Central Valley Regional Water Quality Control Board

NOTICE OF APPLICABILITY

**WATER QUALITY ORDER 2015-0121-DWQ
GENERAL WASTE DISCHARGE REQUIREMENTS FOR COMPOSTING OPERATIONS
RECOLOGY INC.
RECOLOGY BLOSSOM VALLEY ORGANICS NORTH
STANISLAUS COUNTY**

STAFF MEMORANDUM

ATTACHMENT A

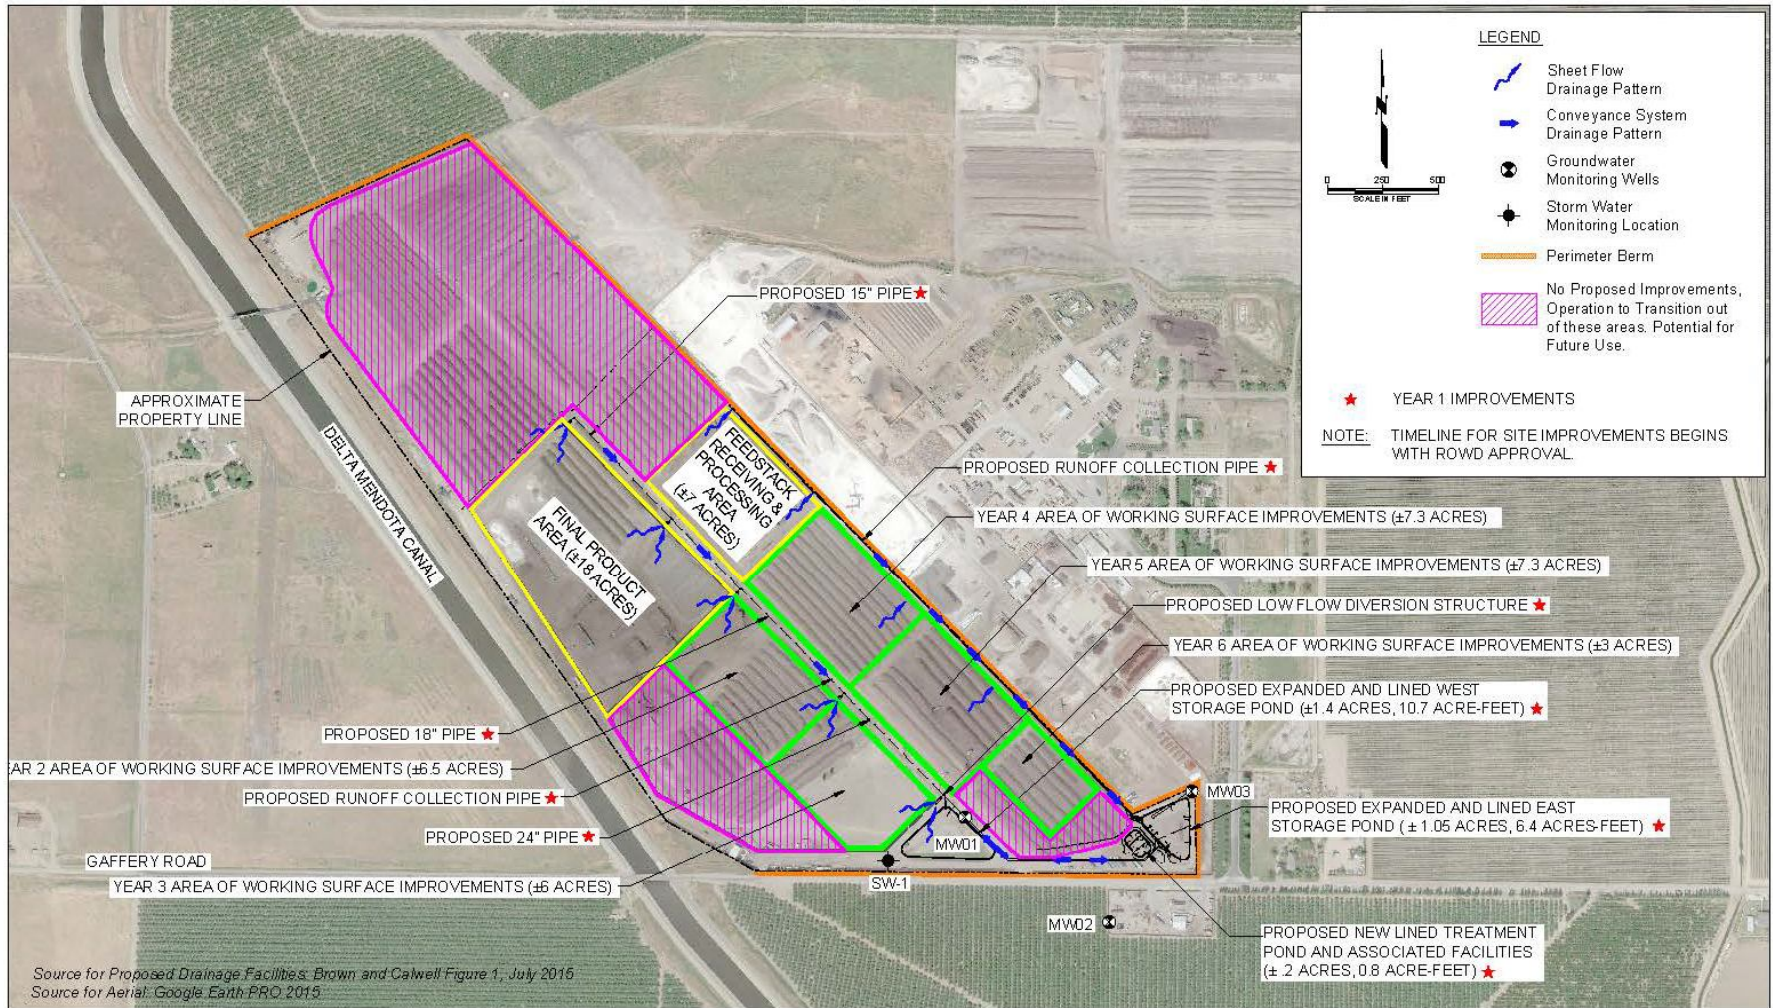
According to the Technical Report update submitted on 22 January 2016, the Discharger plans a significant reduction in the Facility footprint, and they will transition their operations to a smaller footprint as shown on Attachment A. Alternative working surface improvements are proposed to achieve the required hydraulic conductivity and include cement treated base with a minimum thickness of one foot, asphaltic concrete or Portland cement, or a combination,

The table below shows the proposed improvement plan schedule which incorporates on-going operations of the facility, seasonal weather, fluctuations in the market demand of finished product, and company resources. As shown on Attachment A, the proposed improvement plan includes a significant reduction in the footprint of working surfaces. RBVON must comply with the proposed timeline.

depending on operational use. The Discharger is required to submit a revised NOI if their plans for the working surface size changes.

The Discharger must submit a technical report with design information at least 90 days prior to new construction of working surfaces, detention ponds, berms, ditches, or any other water quality protection containment structure for approval by the Central Valley Water Board. The design information must include water balance calculations for detention ponds, design of wastewater conveyance features, liner materials and thicknesses, and rationale for liner system design. The technical report must ensure testing and quality assurance of liner materials and compacted soils in accordance with commonly accepted engineering practices, American Society for Testing and Materials test methods, and/or other appropriate material standards. The Discharger must submit a post-construction report to the Central Valley Water Board within 60 days of completing all construction activities associated with all applicable containment and monitoring structures, as required for compliance with this General Order and the MRP.
